# Access Compliance Report

## Public Rights-of-Way

Intersection ID: 13749	Main Street: BARRINGER_DR	Cross Street: REMOUNT_RD	Location: SW
ADA ID: F01F59F566A9	Ramp Type: PerpDiag	Initial Pass/Fail: Fail	Overall Compliance: No
Severity Score: 25			
Codes/Mitigation Info/Possible Solution		Field Measurements/Component Compliance

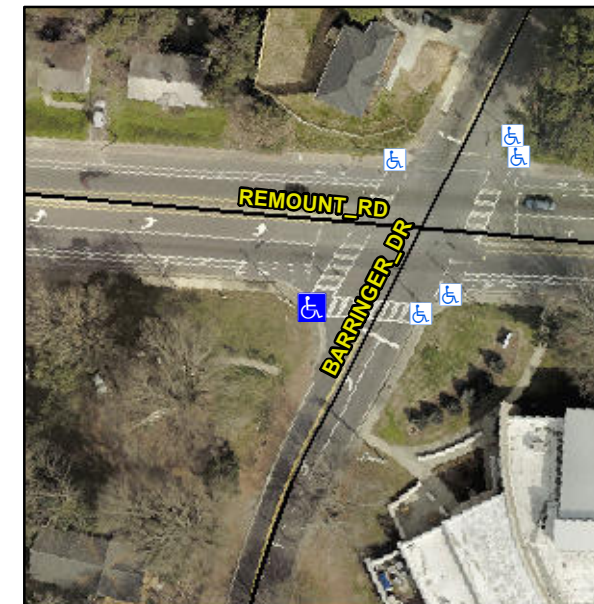
**Not Found, R304.2.2**

Compliance	Description	Data	Compliance	Description	Data
N/A	Ramp Length (in)	58.0	No	Ramp Slope (%)	12.2
Yes	Ramp Width (in)	48.0	Yes	Ramp XSlope (%)	2.0
N/A	Flare Type LT	N/A	N/A	Flare Type RT	N/A
N/A	Flare Slope LT (%)	N/A	N/A	Flare Slope RT (%)	N/A
N/A	Flare Traversable LT?	N/A	N/A	Flare Traversable RT?	N/A
N/A	Landing Length (in)	N/A	N/A	DWS Provided?	N/A
N/A	Landing Width (in)	N/A	N/A	DWS Contrast?	N/A
N/A	Landing Slope (%)	N/A	N/A	DWS Length (in)	N/A
N/A	Landing X Slope (%)	N/A	N/A	DWS Full Width?	N/A
N/A	Landing Curb? (Y/N)	N/A	N/A	DWS Offset (in)	N/A
N/A	Shared Landing?	N/A			
N/A	Gutter Ponding?	N/A	N/A	Gutter Slope (%)	N/A
N/A	Gutter Lip Ht (in)	N/A	N/A	Gutter X Slope (%)	N/A
N/A	Painted X Walk1?	Yes	N/A	Painted X Walk2?	Yes
	X Walk 1 Direction	To E		X Walk 2 Direction	To NE
N/A	X Walk 1 Width (in)	118.0	N/A	X Walk 2 Width (in)	123.0
	X Walk 1 Slope (%)	1.7		X Walk 2 Slope (%)	1.9
	X Walk 1 X Slope (%)	0.5		X Walk 2 X Slope (%)	1.6

**Remove & Replace Curb Ramp With Two New Directional Ramps or Equivalent.**
